# CITY OF West Linn

## PLANNING MANAGER DECISION

FILE NO.: WRG-15-06/MIS-15-13

REQUEST: Request for a Flood Management Area (FMA) permit and Willamette and Tualatin River Protection (WRG) permit for a boat dock and ramp at 17856 Robin View Court.

**Boat Dock**  
 17856 Robin View Ct.  
 Joe and Pam Wilhelm

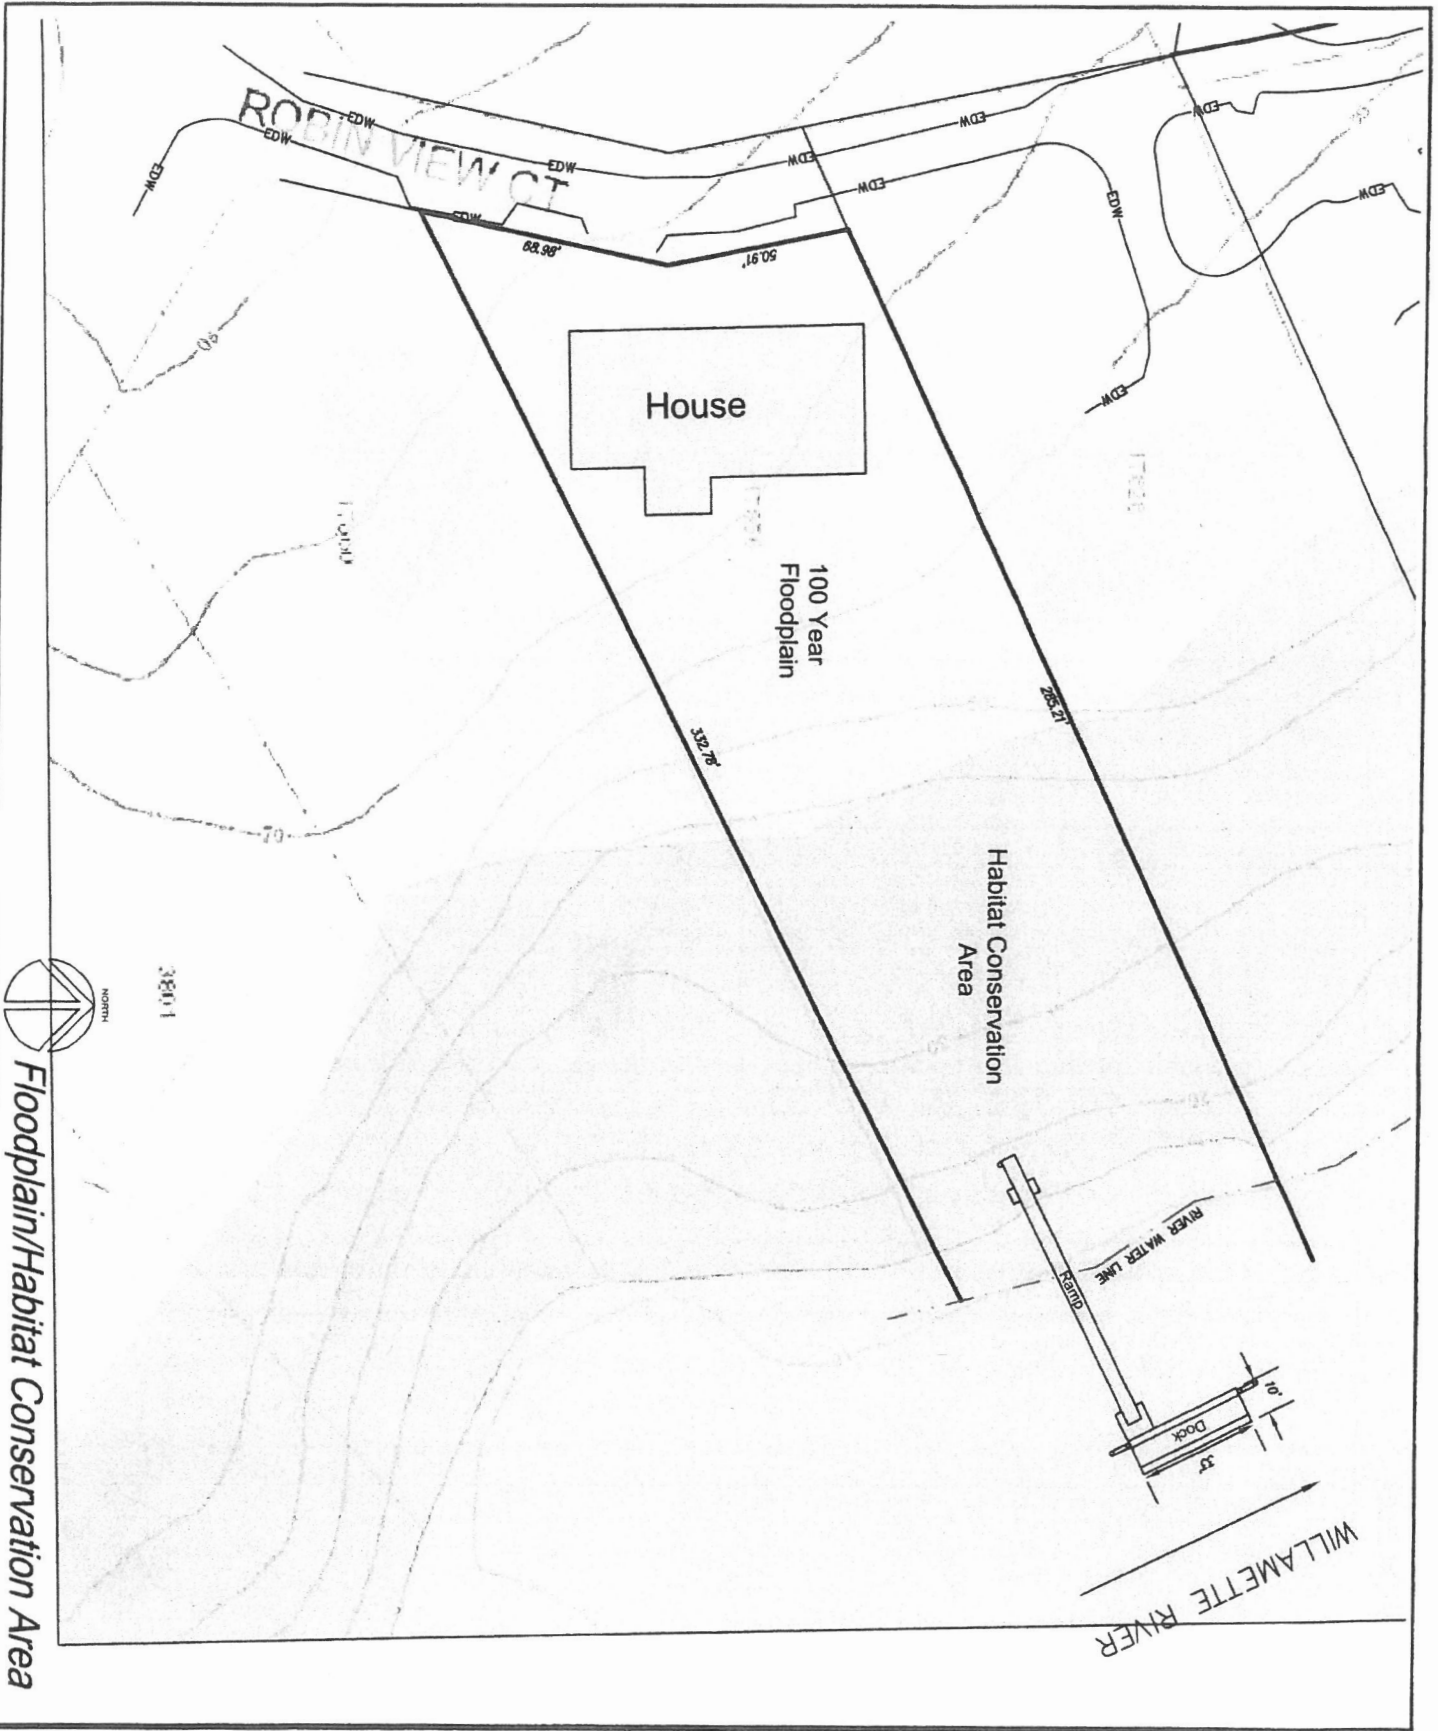
**Staff Finding 2:** The ramp and dock will be generally centered on the lot's river frontage, per the applicant's site plan, within the Oregon Department of State Lands (DSL) authorized portion of the preference right boundary, per Condition of Approval (COA) 2. Therefore, the 7.5 foot side yard setback will be met. The criterion is met by condition.

**Staff Finding 15:** The applicant's submittal shows that the ramp and dock will be generally centered on the lot's river frontage in accordance with the criteria above. The final ramp and dock location will be dependent upon the Department of State Lands' (DSL) delineation of the authorized portion of the preference rights area. (DSL has yet to establish the authorized area since that is a parallel permitting process.) The dock will be placed accordingly, per COA 2. (This should also address concerns raised by the neighbors, Dan and Brenda Shear, regarding the dock's proximity to their common side lot line.)

Cross Section  
Scale: 1" = 20'

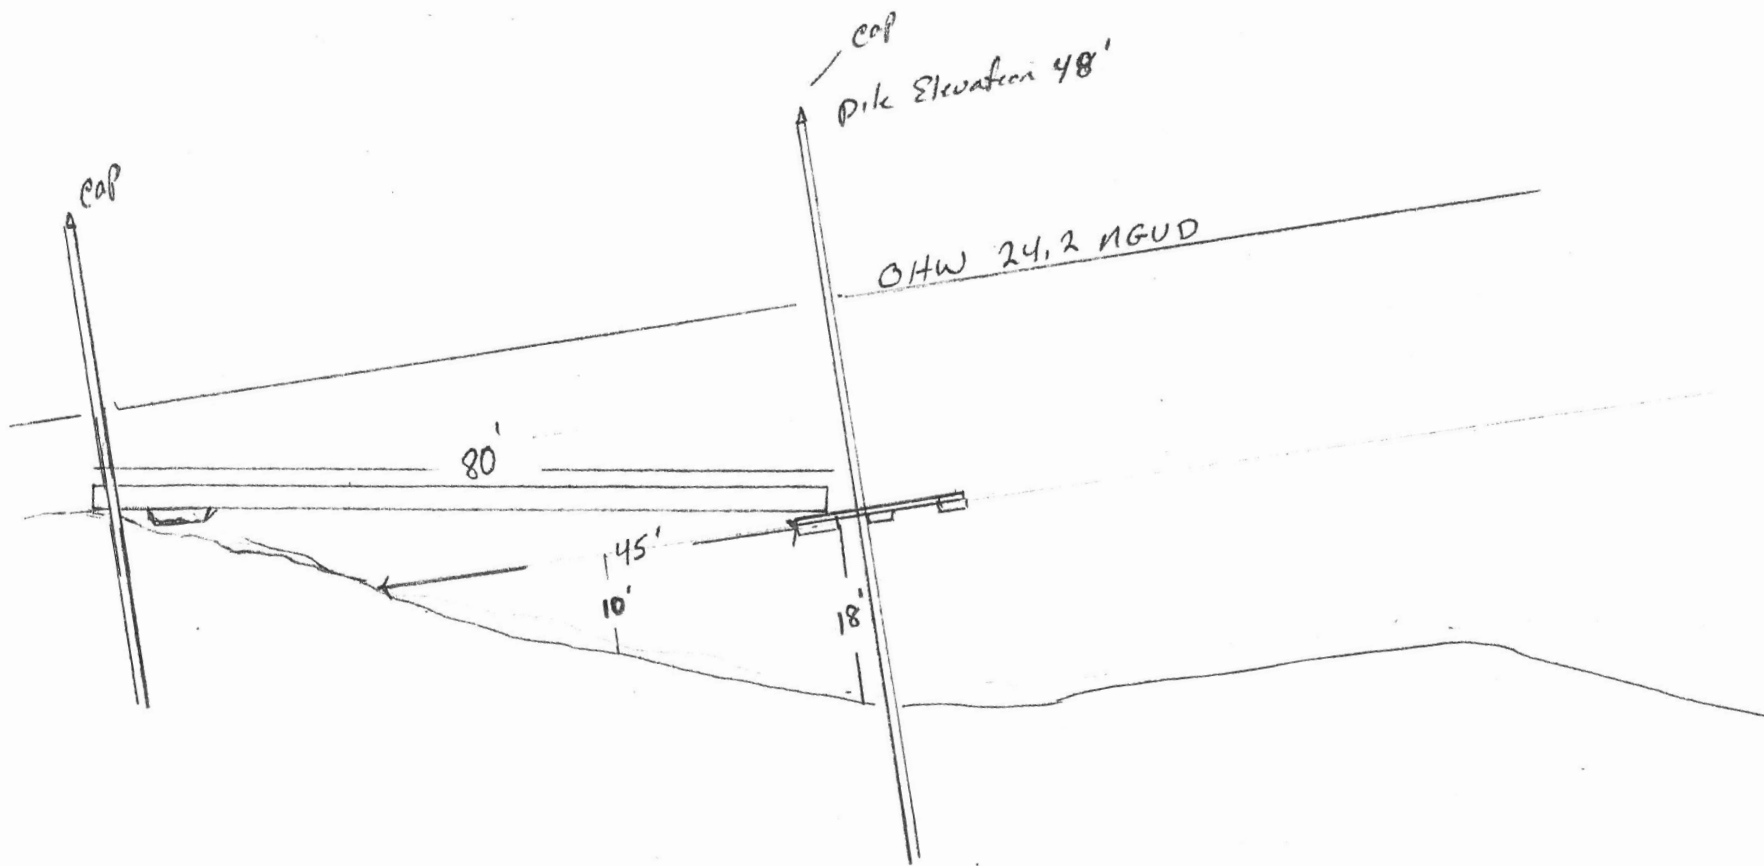
**Staff Finding 16:** The applicant's profile drawing shows that the dock will be at a 16-20 foot water depth at OLW. This exceeds the "*four feet between the ship's keel*" standard. The applicant must modify the dock and ramp design to demonstrate that the four foot depth between the ship's keel or fixed propeller/rudder and the bottom of the water at any time during the water's lowest point is met. Therefore this criteria is met by COA 1.

- 1.) The applicant shall provide modified plans that demonstrate the dock and ramp are designed to comply with the four foot depth between the ship's keel or fixed propeller/rudder and the bottom of the water at any time during the water's lowest point is met.
- 2.) The ramp and dock will be generally centered on the lot's river frontage, per the applicant's site plan, within the Oregon Department of State Lands (DSL) authorized portion of the preference right boundary.
- 3.) The applicant will provide an Engineer's stamped and signed finding that the dock, ramp and pilings will not increase in flood levels during the occurrence of the base flood discharge and will not impact the flood-carrying capacity of the river. The report must
